Staff Summary Report

SUBJECT: Hold a public hearing for a Planned Area Development Overlay and Development Plan Review for CAMPUS EDGE located at 922 East Apache Boulevard.

DOCUMENT NAME: DRCr_CampusEdge_012208

COMMENTS: Request for **CAMPUS EDGE (PL070224)** (Tim Becker, Nelson Companies 2, LLC., applicant/owner) for the development of a mixed-use project consisting of a mid-rise building with two wings totaling 269,640 square feet, including residential student housing and ground floor commercial on approximately 1.50 acres, located at 922 East Apache Boulevard, in the MU-4, Mixed Use High Density District, Transportation Overlay and Planned Area Development Overlay. This request includes the following:

SITE PLAN

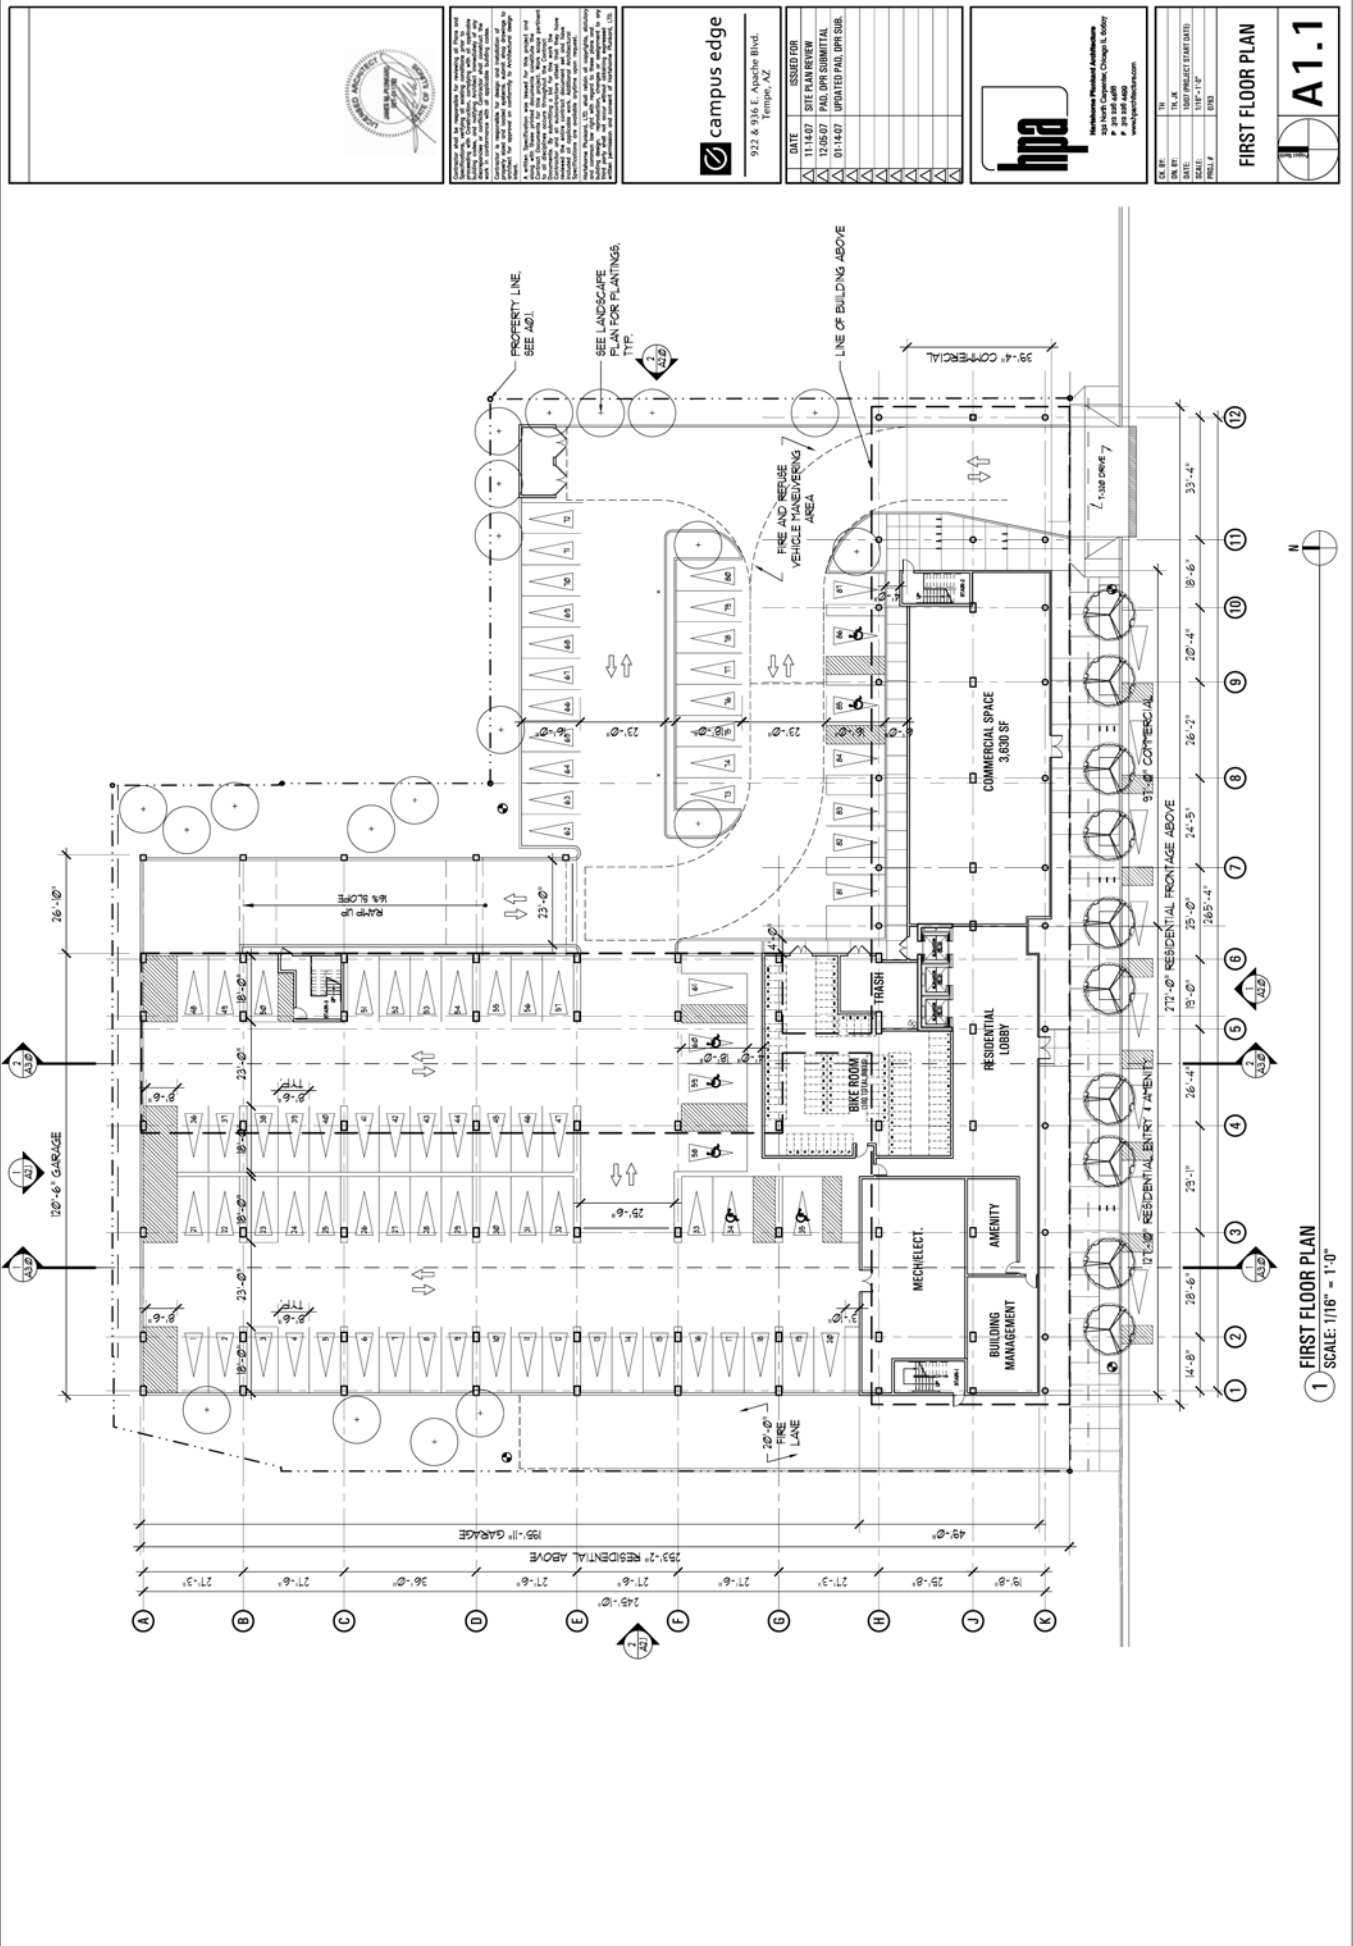
9. Provide 8'-0" wide public sidewalk clear of any obstructions, along Apache Boulevard, or as required by Traffic Engineering Design Criteria and Standard Details.

10. Provide pedestrian amenities within the 6' area near curbside, including but not limited to benches, drinking fountains, public art, kiosks or other design elements as deemed appropriate.

11. Provide service yard and mechanical (cooling tower/generator) yard walls that are at least 8'-0" tall as measured from adjacent grade and are at least the height of the equipment being enclosed, whichever is greater. Verify height of equipment and mounting base to ensure that wall height is adequate to fully screen the equipment. Locate electrical service entrance sections inside the service yard, as indicated.

13. Provide upgraded paving at each driveway apron consisting of unit paving. Extend unit paving in the driveway from the back of the accessible public sidewalk bypass to at least 20'-0" on site and from curb to curb at the drive edges.
